Groundwater Transfer Review Summary Form

Transfer/PA # T- 13858

Application: T-13858

Applicant Name: Stauffer Farm Inc.

Drawdown calculations for MARI 69905 impacts to neighboring MARI 51008 at currently authorized rate of 0.673 CFS. Increases in rate at this proposed APOA may result in injury to neighboring right Certificate 92328.

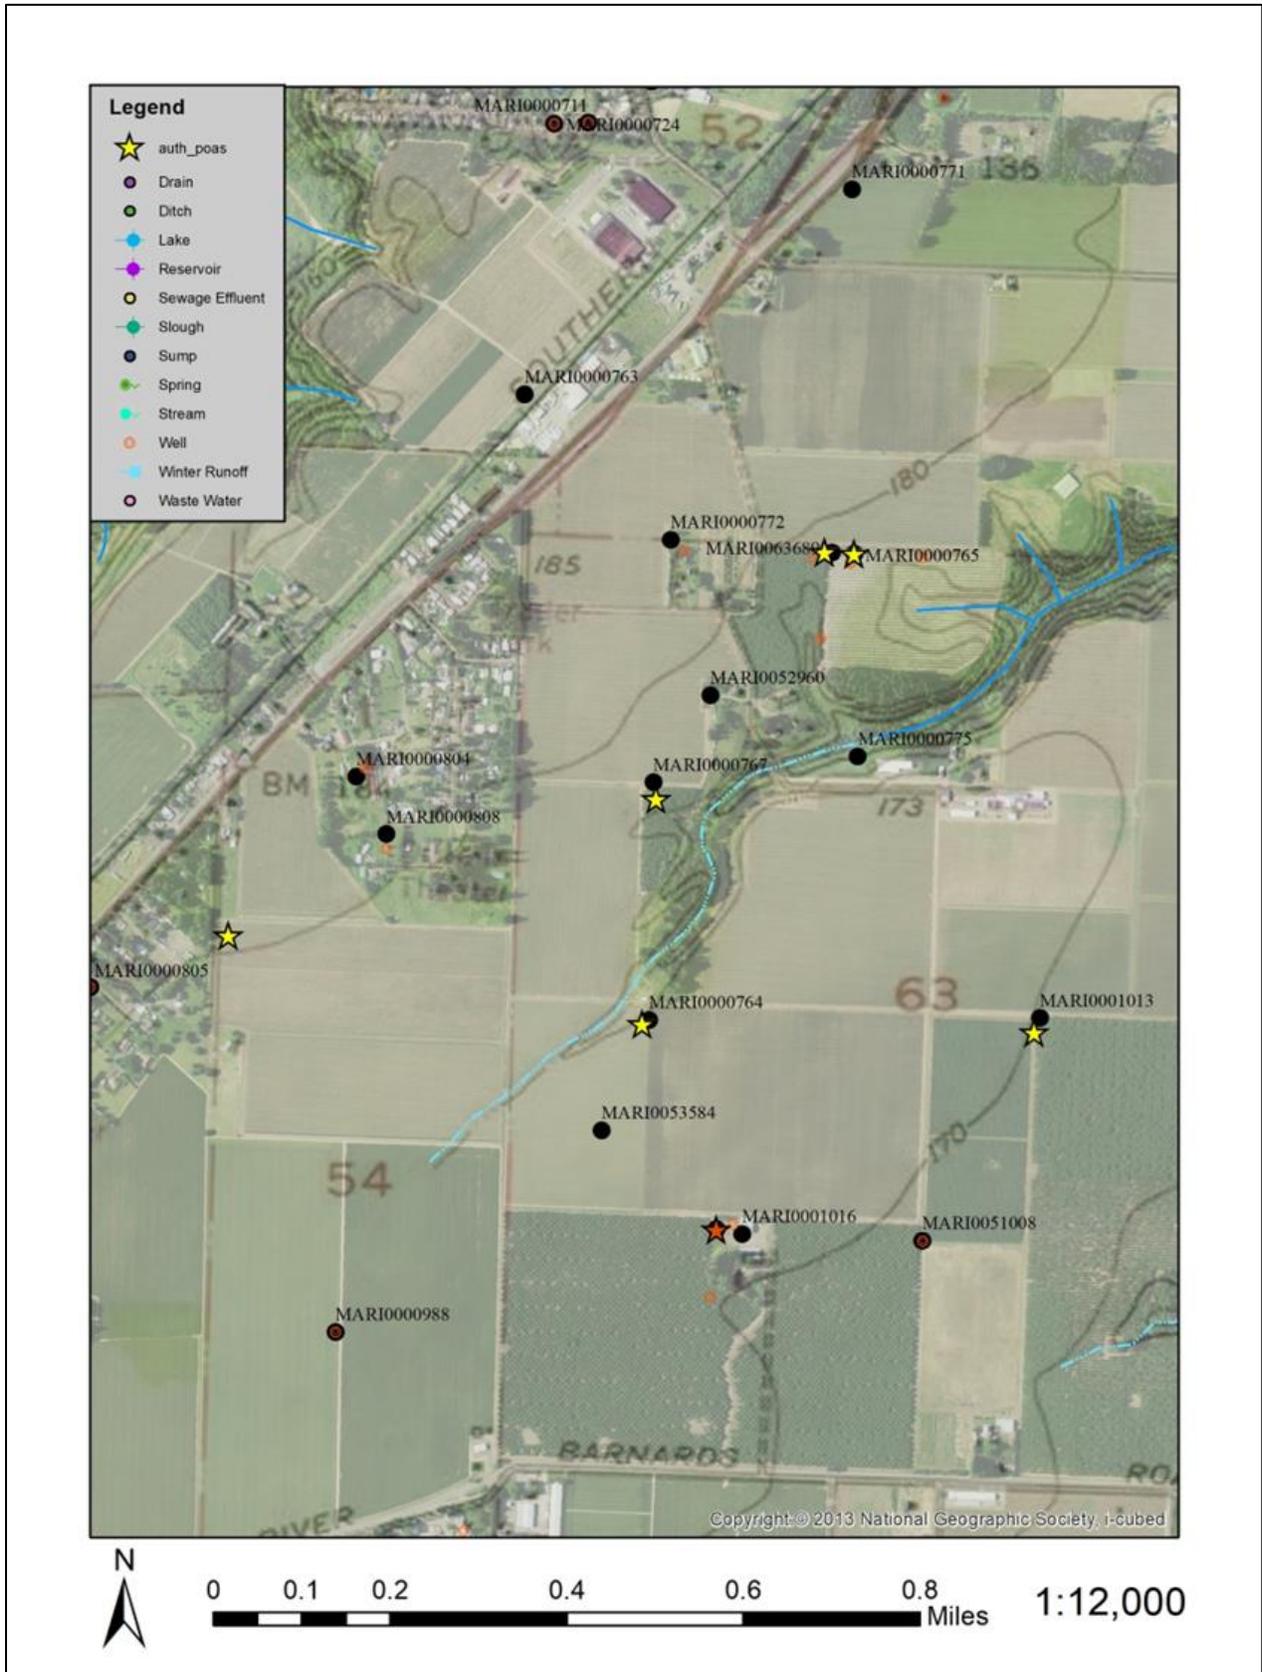
4. a) Will this proposed change, at its maximum allowed rate of use, likely result in an increase in interference with **another ground water right**?
 Yes No Comments: The proposed changes shift pumping from several wells, most with minimal resulting change in expected pumping volume per season. The largest expected net change in pumping due to the proposed changes is the newly added MARI 69905 (see attached tables). MARI 51008 authorized under Certificate 92328 is the nearest well to proposed APOA MARI 69905, at a distance of 1,235 feet.

MARI 69905 is currently authorized under Permit G-18537 at a maximum rate of 0.673 CFS, limited by the 80% exceedance flow in the resident WAB. Using parameters included in the original application review (G-18923; Travis Brown), an increase in pumping as a result of this transfer is likely to cause injury at MARI 51008, with expected seasonal drawdowns between 15-50 feet. If the maximum rate at MARI 69905 is maintained at the authorized rate under G-18537, however, the most reasonable estimates of drawdown lie between 11-16 feet. In addition, MARI 69905 is proposed as an APOA on GR Modification T-13861, where it, and a combination of other existing wells are replacing abandoned POA MARI 1016.

7. What conditions or other changes in the application are necessary to address any potential issues identified above: To avoid injury with nearby rights, proposed APOA MARI 69905 shall be limited to its previously authorized rates under Permit G-18923 and GR-751 for a total of 1.23 CFS.
